A12 Chelmsford to A120 widening scheme

8.12 Statement of Common Ground with Essex County Council

Statement of Common Ground with Essex County Council

This Statement of Common Ground has been prepared and agreed by (1) National Highways Limited and (2) Essex County Council.

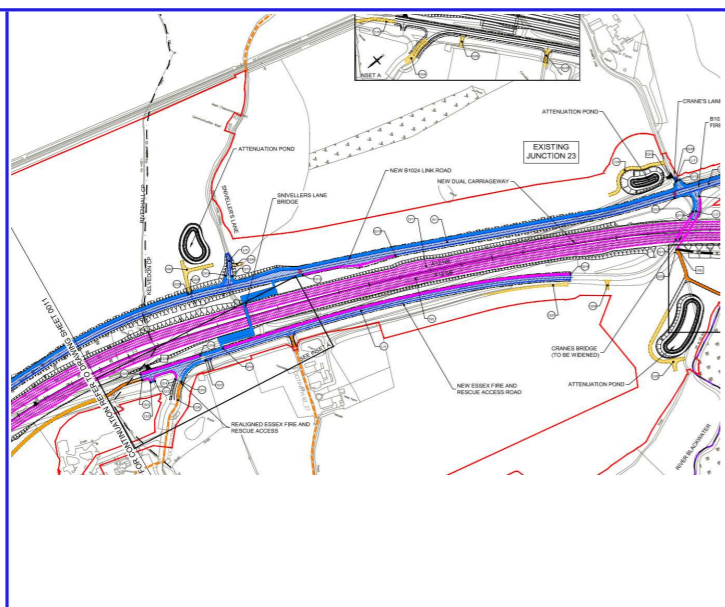
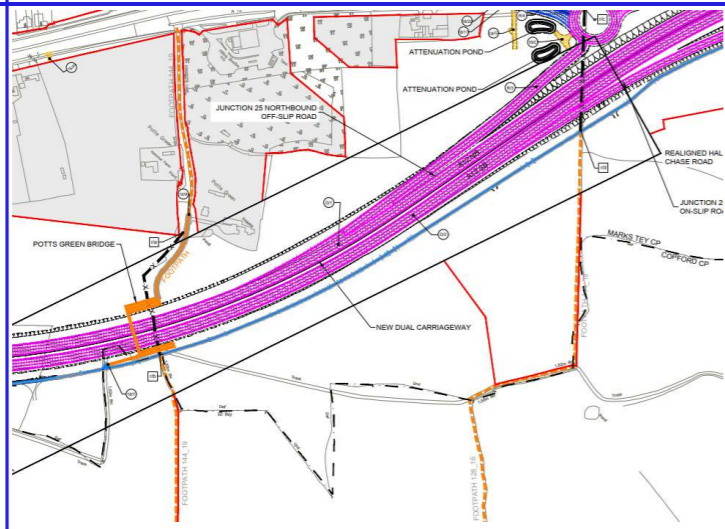
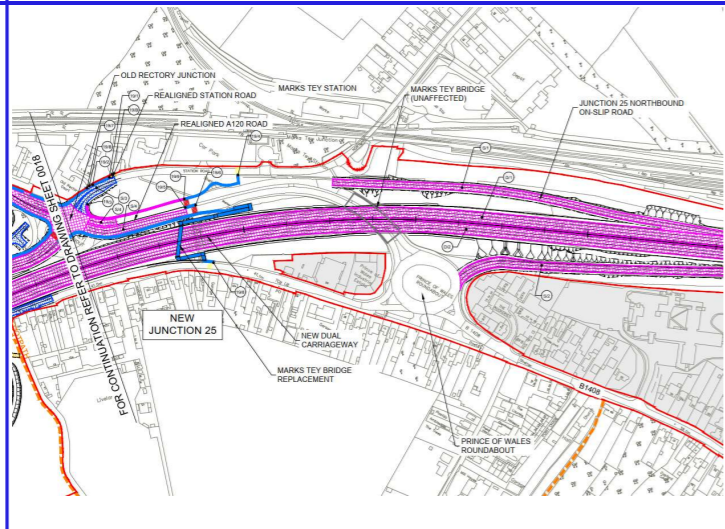
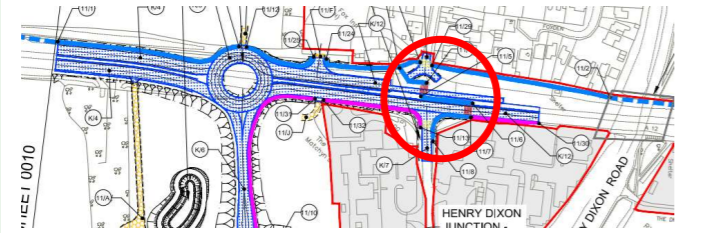
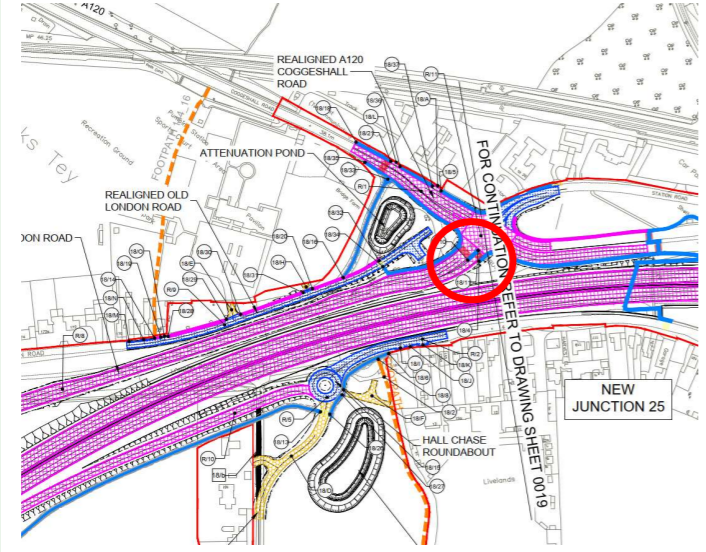
<p>Snivellers Lane Spans A12 by Essex Fire & Rescue HQ</p>		<p>Pedestrians and Cyclists due to new through route between Witham and Kelvedon, and Essex Fire and Rescue</p>	<p>Pedestrians, Cyclists, Ridden horses Unsegregated Shared Use with 4m clear span</p>	<p>Between J22 and J24 connects B1024 and Essex Fire & Rescue HQ</p>	<p>25400, Sheet 12 of 21</p>	<p>Adjacent to northbound carriageway</p>	<p>Ramp direction Between A12 and B1024 with desire line needing to serve northbound and southbound routes equally</p> <p>Ramp radii scope to amend, move controlled crossing if needed, tie in to bus stop connections</p>	<p>Minimal</p>	<p>No change in ramps overall alignment.</p> <p>Investigate scope for minimum 5m radii on all bends (detailed design)</p>	<p>Bridge ramp should be redesigned to provide a more direct route for users, with fewer zig-zag foldbacks, if possible, and 5m radius (minimum) turns where ramp sections change direction – in accordance with LTN 1/20.</p> <p>Evidence has not been provided to prove that all alternative ramp layouts have been exhausted. Further design investigation could reveal suitable alternatives to current design.</p> <p>'Investigate scope for minimum 5m radii on all bends' falls short of actually providing 5m radii on all bends. This should be committed to and design amended</p> <p>The ramps and the bridge itself should be designed in accordance with best practice for pedestrians, cyclists and ridden horses</p>

<p>Potts Green Spans A12 south of northbound diverge to J25</p>		<p>Pedestrians only due to surrounding Footpath 144_19.</p>	<p>Pedestrians, Cyclists, Ridden horses Unsegregated Shared Use with 4m clear span</p>	<p>Between J24 and J25 connects de-trunked A12 to PRoW to the east</p>	<p>37100, Sheet 18 of 21</p>	<p>Adjacent to northbound carriageway</p>	<p>Ramp direction Scope to use earth bund as part of route, but visual intrusion on Doggetts/Potts Green make this unacceptable. Little or no reduction in route length/directness, so benefit does not justify alteration to design.</p>	<p>Potential increase in visual impact - altered visual impact would need review It would bring users in higher position closer to private property and potential for loss of privacy, Possible hybrid solution between zigzag and embankment</p>	<p>No change in ramps overall alignment.</p> <p>Investigate scope for minimum 5m radii on all bends (detailed design)</p>	<p>Investigate scope for minimum 5m radii on all bends' falls short of actually providing 5m radii on all bends. This should be committed to and design amended</p> <p>The ramps and the bridge itself should be designed in accordance with best practice for pedestrians, cyclists and ridden horses</p>

<p>Marks Tey Spans A12</p>		<p>Pedestrians and Cyclists due to wider walking and cycling routes proposed in vicinity and upgrade of A120 crossing to Toucan.</p>	<p>Pedestrians, Cyclists Unsegregated Shared Use with 4m clear span</p>	<p>Replacing existing J25 Pedestrian Bridge</p>	<p>38300, Sheet 19 of 21</p>	<p>Adjacent to northbound carriageway</p>	<p>Ramp direction Issues with the Geometry and changes in levels between A12 and A120 height clearance.</p> <p>Ramp radii On balance no change to overall layout can be justified, provide 5m radii if practicable (note severe constraints)</p>	<p>Minimal- the Loss of some trees on the island between A12 and Station Road to enable the ramp.</p>	<p>No change in overall alignment of ramps</p> <p>5m radii, on all bends (detailed design)</p>	<p>Bridge ramp should be redesigned to provide 5m radius (minimum) turns where ramp sections change direction – in accordance with LTN 1/20.</p> <p>Evidence has not been provided to prove that all alternative ramp layouts have been exhausted. Further design investigation could reveal suitable alternatives to current design.</p> <p>'Investigate scope for minimum 5m radii on all bends' falls short of actually providing 5m radii on all bends. This should be committed to and design amended</p>

Hatfield Peverel Rail Station to Witham

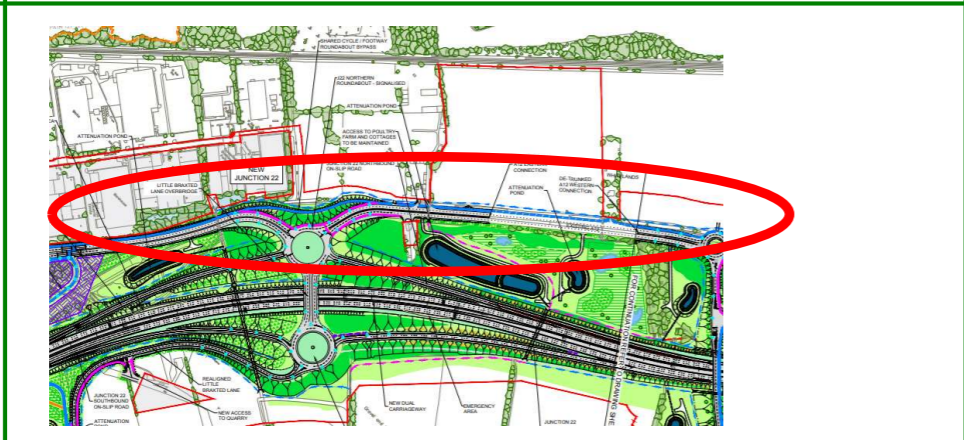
A new walking and cycling route should be included (within the proposed red line boundary) to north of Junction 21, to connect new developments in Witham to Hatfield Peverel station

Junction 22 to Rivenhall

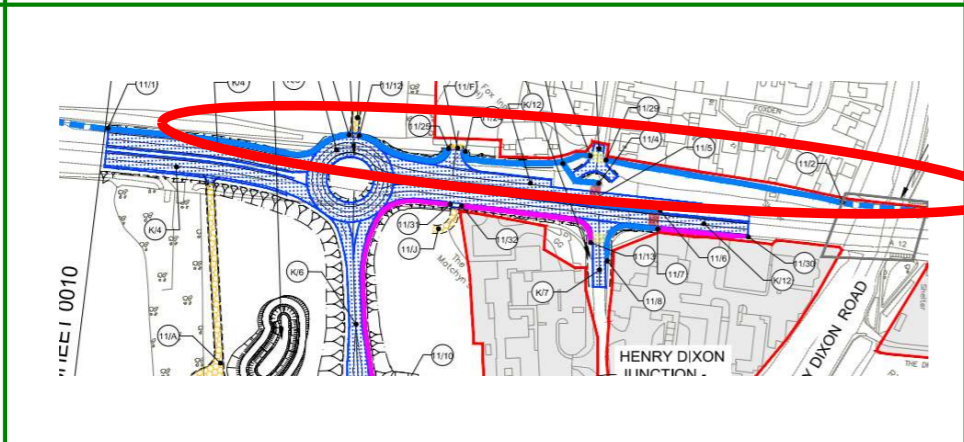
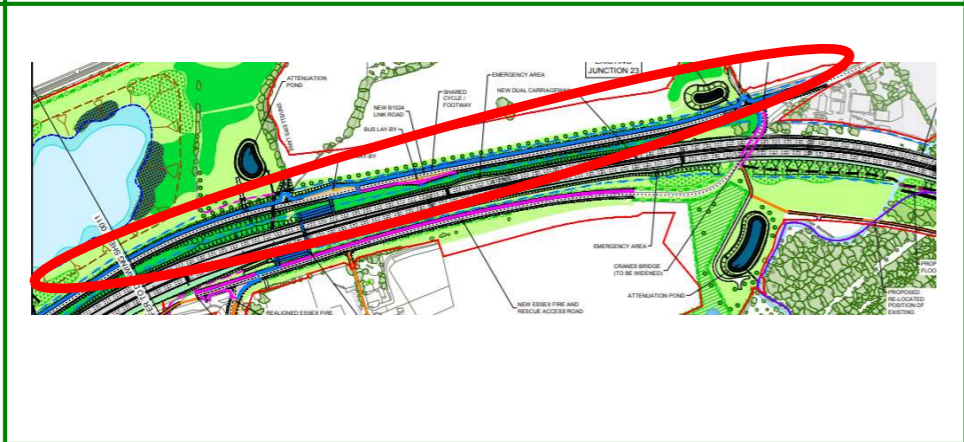
Upgraded walking and cycling facilities should be provided along whole length of de-trunked section to a minimum of 3m wide shared use 2-way cycle/footway.

Rivenhall

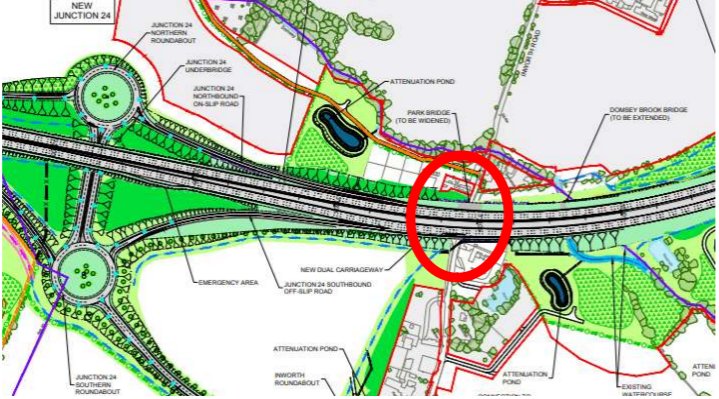
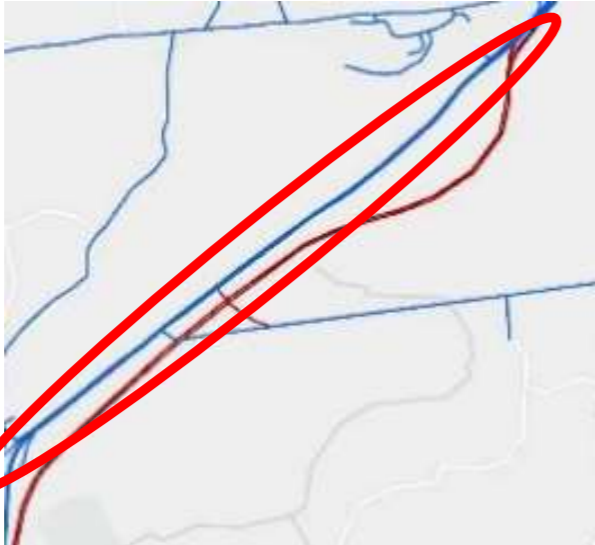
Upgraded walking and cycling facilities should be provided along whole length of de-trunked section to a minimum of 3m wide shared use 2-way cycle/footway.

Duke of Wellington junction in strategic model

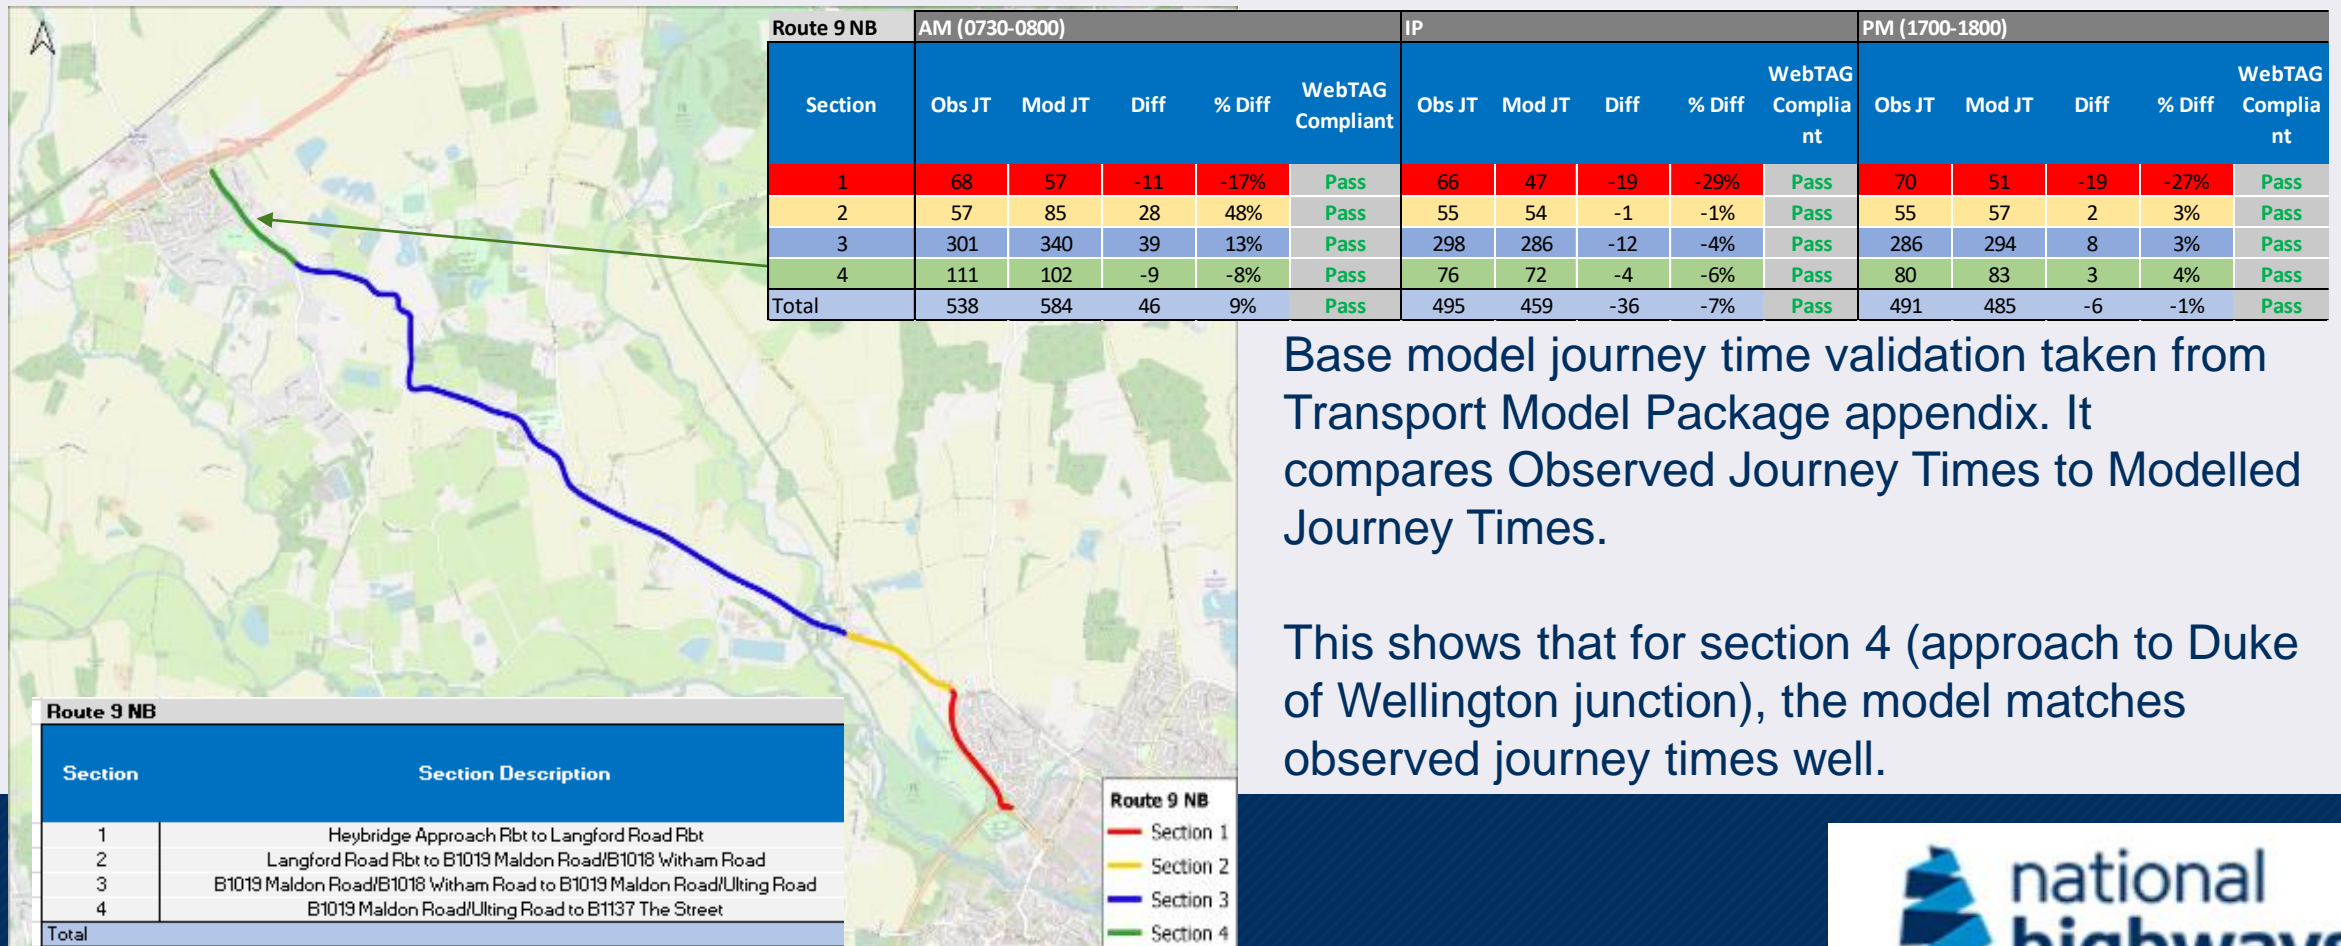
Duke of Wellington junction-specific data from the Strategic Model – there is a concern that the performance of the Duke of Wellington junction within the strategic model could under-estimate the expected delays to traffic (especially traffic approaching the junction from Maldon Road) and that therefore the potential for traffic to seek to “rat run” via Church Road and/or Remembrance Avenue / New Road is also being under-recognised. Journey time data from the strategic model for the journey from Ulting Road/B1019 Maldon Road to the Duke of Wellington junction (including V/C and delay at the junction) is therefore requested for the purposes of comparison with the junction-specific modelling.

Route from Tiptree to Rivenhall End (via B1022 Maldon Road, Braxted Park Road and Station Road) – a select link analysis is requested to identify volumes, origin and destination points for traffic using the route between Tiptree and Rivenhall End.

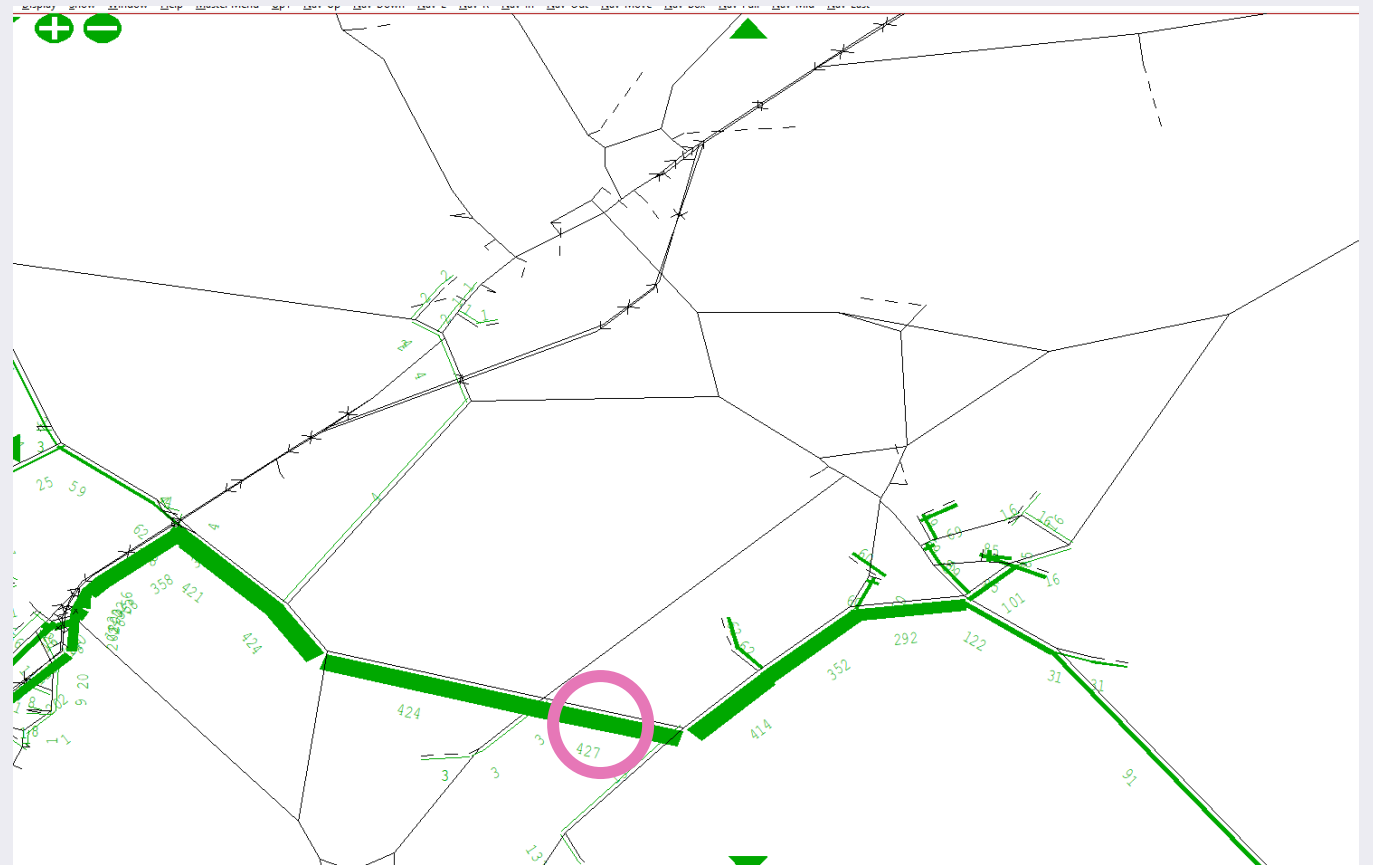
We would like the select link analysis to be carried out for the base model, “without A12 scheme” and “with A12 scheme” in 2027 and 2042.

For ease of display, analysis is only shown for 2027 AM

Comparison of observed vs modelled journey times from Tiptree to A12 via Braxted Park Road

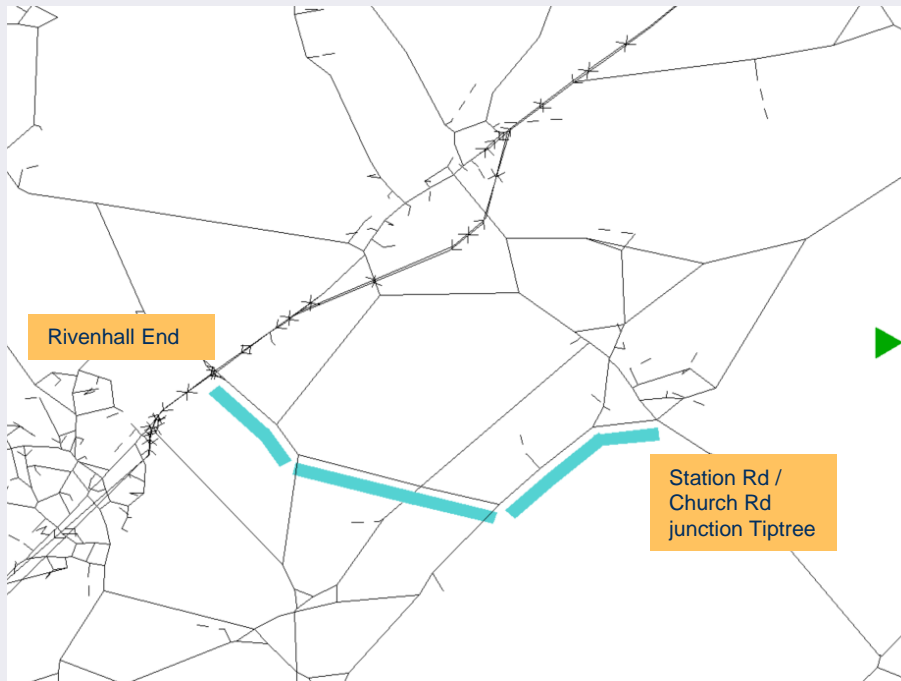
This route was not included as a journey time route in the traffic model's calibration / validation, so is not reported in existing documentation. However, journey times from the base model have now been extracted and compared to observed Traffic Master data.

Time period	Observed JT	Modelled JT	Difference (seconds)	Difference (%)
AM	9 min 1s	8 min 23s	-38s	-7%
PM	8 min 48s	7 min 34s	-74s	-14%
